New Reactors Programme
GDA close-out for the AP1000 reactor
Internal Hazards GDA Issues GI-AP1000-IH-01 to IH-06

Assessment Report: ONR-NR-AR-16-020
Revision 0
March 2017

This report is the Office for Nuclear Regulation's assessment of the RP's **AP1000** reactor design in the area of internal hazards. Specifically this report addresses GDA issues:

Figure 1 - Simplified elevation schematic of the PXS Room A and Room B

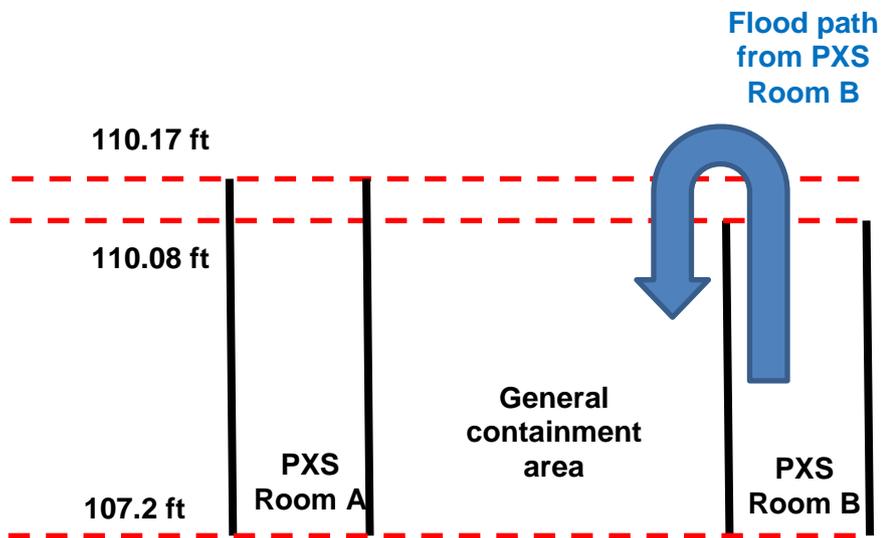
206. I noted that the margin between the heights of the partial walls inside Containment appeared to be minimal from Figure 10-1 of the flooding Topic Report (Ref. 73). For example, PXS Room B has a partial wall of 110.08ft compared with PXS Room A which has a wall height of 110.17ft. The layout of the PXS Rooms is identified in the flooding Topic Report under Figure 10-14 which shows elevation 92'-6" and the associated partial walls are identified in Figure 10-15 on elevation 100' 0" (Ref. 73).

207. I sought clarification on the layout and flood path inside Containment. From my discussions with the RP, it was observed that Figure 10-1 (flooding topic report, Ref. 73) is slightly misleading. I created Figure 1 (Annex 1) which shows a simplified elevation schematic of the PXS Room A and Room B. This is to aid my understanding and readers of the flow path inside Containment.
